meeting minutes

Pro	ject No.:	R3001.405.00	File No.(s):	0.10.0
	Dat	e Prepared:	November 7, 2018		
	Mee	eting Date:	November 1, 2018		
Project Name:	University of Wisconsin-La Cross	e- New Stude	nt Fieldhouse & Soc	cer Support Facil	ity (DFD 15121)
Subject:	Executive Committee Meeting	10am	- Noon		
Meeting Attendees:	See meeting attendance list attac	ched

Design Workshop #05 - Executive Committee - November 1, 2018

Overall – Site Plan

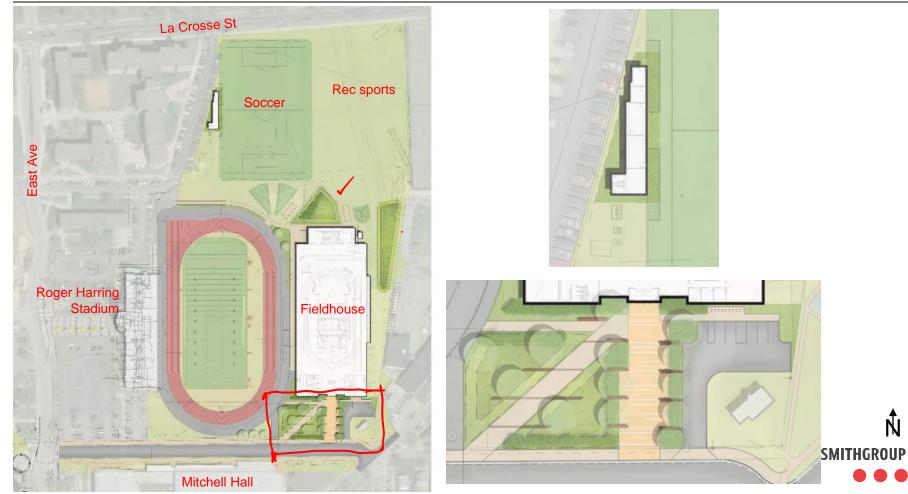
- 2) Site Plan was review by Nate Novak
 - a) Existing access road gate to visitor football is being shifted to west
 - b) Is paved fire access be required on northeast side of site?

- i) Nate Novak will reach out to fire department to talk through what will be required.
 - c) Add gates to perimeter fence that align with overhead doors in building

- d) Gator access at northwest track for athletics will connect to track, grounds crew will want connection north to road
 - e) Bob H. noted side walk north of outdoor track needs to connect into stadium as well as existing sidewalk

- f) Bob would prefer that the area just north of building is open, not a detention area
 - g) Could the primary detention be on the east side in easement?

- h) The raingarden could be a bridge like being designed at centennial hall. Needs to have more direct access from soccer spectator seating as well as students playing rec sports on soccer artificial turf.

- i) Standard acorn lamp is desired with banner incorporated. Pole banners have not been an overarching feature on campus.
 - j) Sidewalk next to street needs to be concrete, no pavers allowed

- k) 15' wide diagonal access on south side encourages vehicle access, introduce deterrents at street
 i) Scott S. noted brick paver needs to avoid city street.

- I) Uniform planting in basins is good
 - m) Dumpsters will be located at Mitchell, trash will be carted across the street. Will need to locate collection area inside the building.

- n) Access to new ADA parking will require moving a current bus stop

• Pedestrian access appears accurate, however more direct access from the soccer and rec fields to the north restrooms of the fieldhouse needs to be accommodated. The rain garden as shown pushes traffic to the far east end

• Fire and service access reviewed and appears accurate. SmithGroup to setup Conf. call for fire department review with Scott.

Site Fencing Diagram

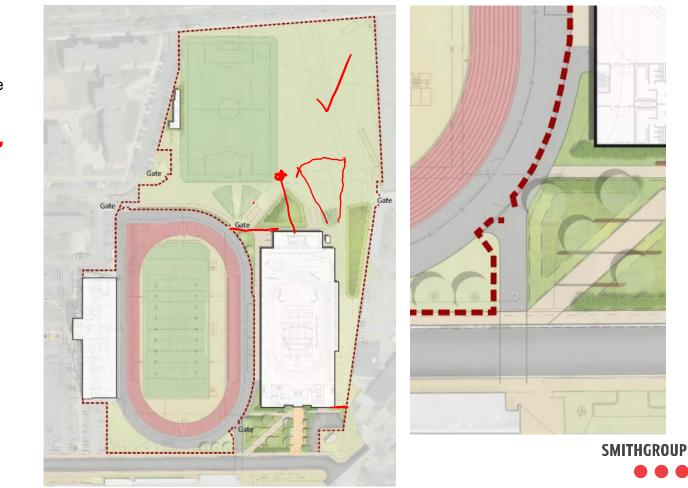
- Add gates along west side in alignment with west garage door locations to provide overflow and access to FH from the stadium and track.
- Soccer and rec field areas need to be secured. Add fence at SE FH corner and NW FH corner (gates at NW) to close off south end of field areas.
- Gator path north of the track needs to connect to the outer stadium perimeter path and to the Reuter Hall parking lot. There was a 2018 project that added a mountable curb at the bend in the Reuter parking lot that the new gator path should connect with.

Stormwater Treatment Areas

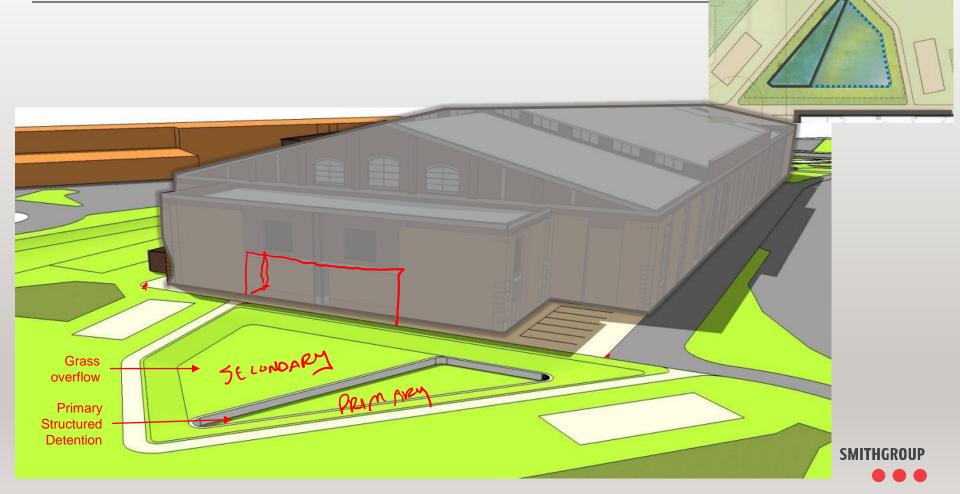
- Project is located within well head protection zone which prohibits active infiltration so while we can temporarily detain water, we cannot retain and infiltrate water on site so we are designing for controlled release. Local infrastructure is also over capacity further complicating stormwater management. The stormwater design is addressing to accommodate predevelopment runoff conditions. Rain gardens as shown are going in the right direction. The north stormwater concept idea is good, but needs to provide more direct path to the restrooms as mentioned above. A bridge or bisected RG area would be OK if needed. The east area shown can be considered but needs to be reviewed with the Water utility since it would be within the water main easement.

- South RG concept is good. Concept mimics the Centennial hall bridge design but rather than a cantilevered walk, the current design is an elevated walk but adjacent grade side slopes away toward the RG basin. Stormwater is conveyed via pipe below the walk and daylights through runnels to the basins east and west.

1 | Fieldhouse – Basement Floor Plan

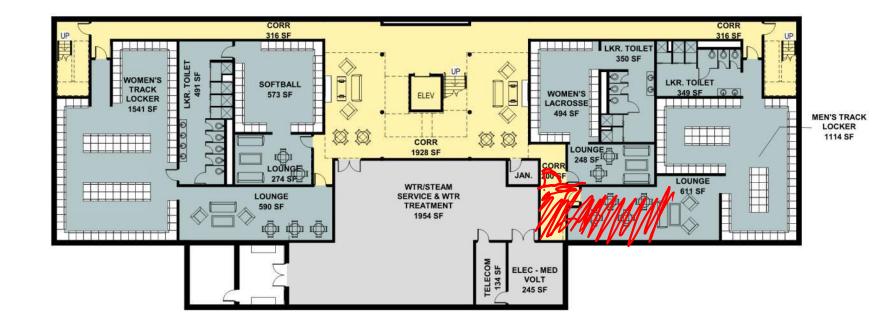
- 3) Brad Rodenburg, RDG, reviewed the Floor Plans
 - a) Confirm with athletics that they want separate showers/toilets at women's track and softball
 - b) Upper team room storage is not needed

1| Fieldhouse – Spectator Seating

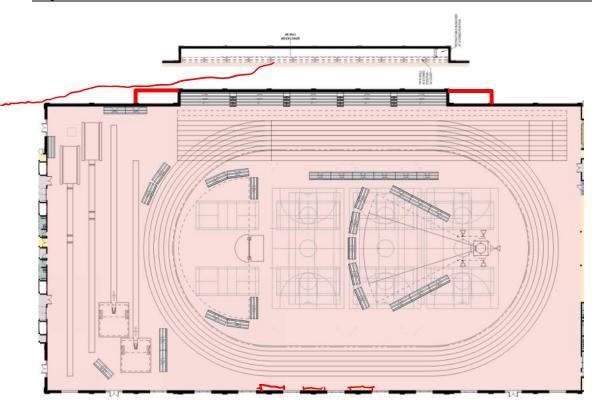
- h) Bob wants to see diagram of tilt and rolls stored
 - i) Interest in adding additional shoulders to seating bump out for more retractable seating
- 4) Building exterior was reviewed by Hoang Tran, RDG.

Protecting Non-Spikable Flooring

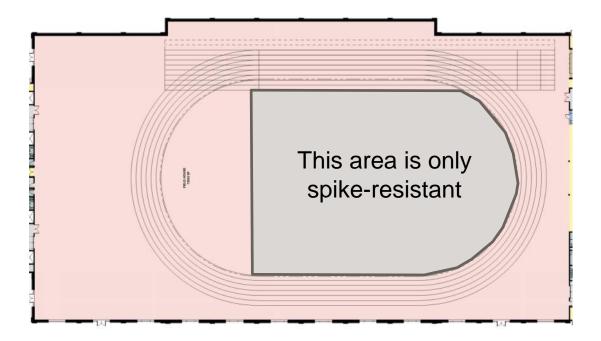
• There were concerns about the **separation of spikable and non-spikable athletic surfaces.** Review committee were concerned that non spikable surface would be damaged by athlete's cleats without proper protection.

- Key here is 'Spikable' vs- 'Spike-Resistant'
- Extent of this area will be determined by other field events that are potentially moved into the in-field area. The driver here is Indoor Track

Showers in General Lockers

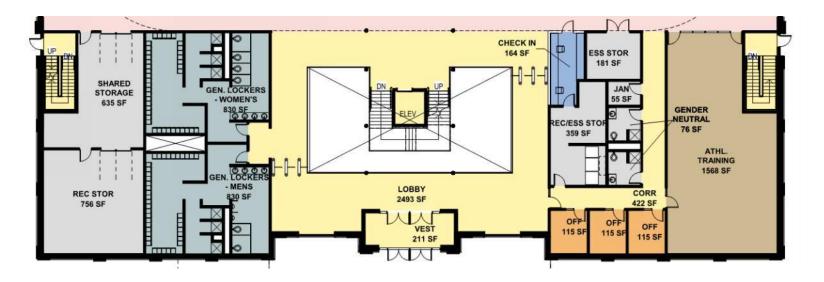
• There were concerns about the south general use (main level) locker rooms and **if the showers would get used**. Review with user if the mix of lockers to showers is correct.

*Will proceed with the showers, as shown

Acoustical Control

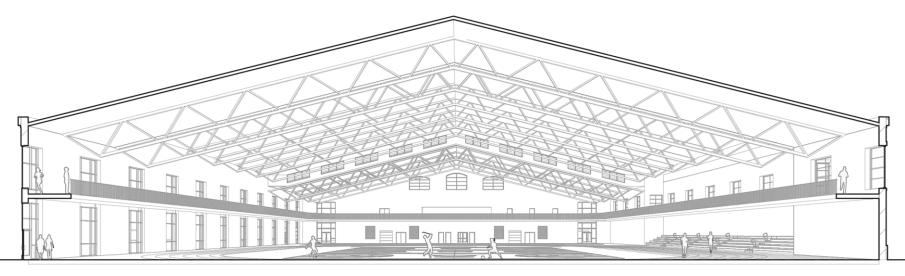
• Acoustic control were a concern for an active, large open space. Design team are planning on using acoustical decking in the field house to absorb reverberation. Review committee requested to see additional acoustic strategies.

*Pro Audio is proceeding with putting together a model and providing a report with additional acoustical considerations

FIELDHOUSE – ROOFING MATERIAL

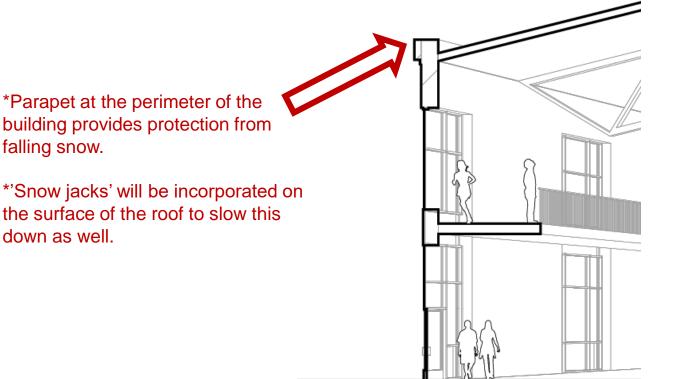
• Review committee posed **questions about roof materials**. Roof can be seen from the football stadium as well as from Grandad bluff. Review committee suggested roof **needed to be aesthetically pleasing texture/color while avoid glaring** issues.

*Design team proceeding with either of the two options, either a membrane with battens or a standing seam metal with a glare-resistant coating.

*Classic gray or similar for color.

Air Circulation

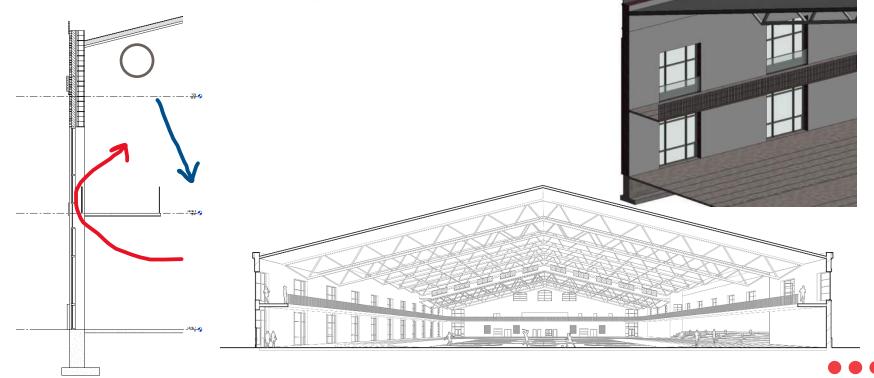
• Review committee had some concerns regarding **air circulation** in such a large space and **in particular the area under the overhead track**. Review committee requested to **see air circulation strategies**.

Multiple Entrances, Large Events

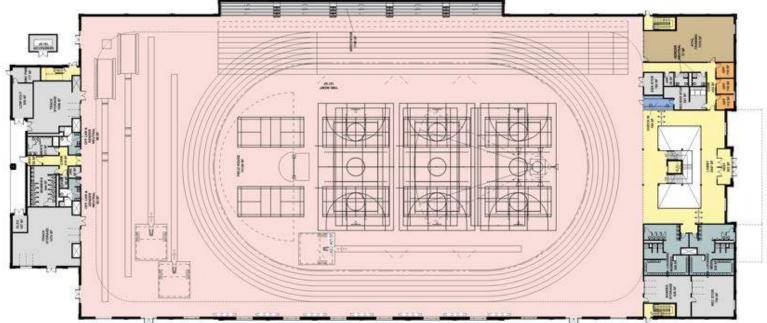
• Review committee had questions about flow of vehicular and pedestrian traffic on site during large events. Committee **suggested having more than one entrance for large events**.

*Main entry will remain at the South, with main check-in here.

*Overhead doors and other controlled points of access around the building for events.

SOUTH FACADE

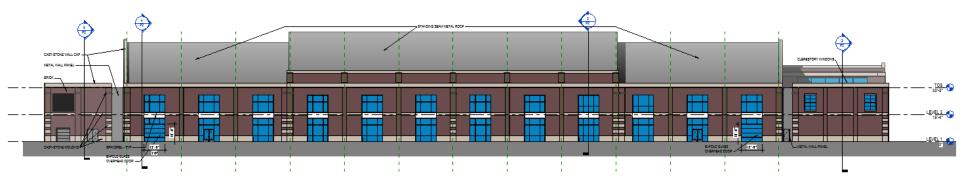
- Review committee noted the design of the south façade needed more experimentations with proportions and brick / cast stone ratio. The façade needed to be even more inviting for students and campus.
- East façade was not discussed during presentation and needs further refinement in regards to being the new east edge of campus.
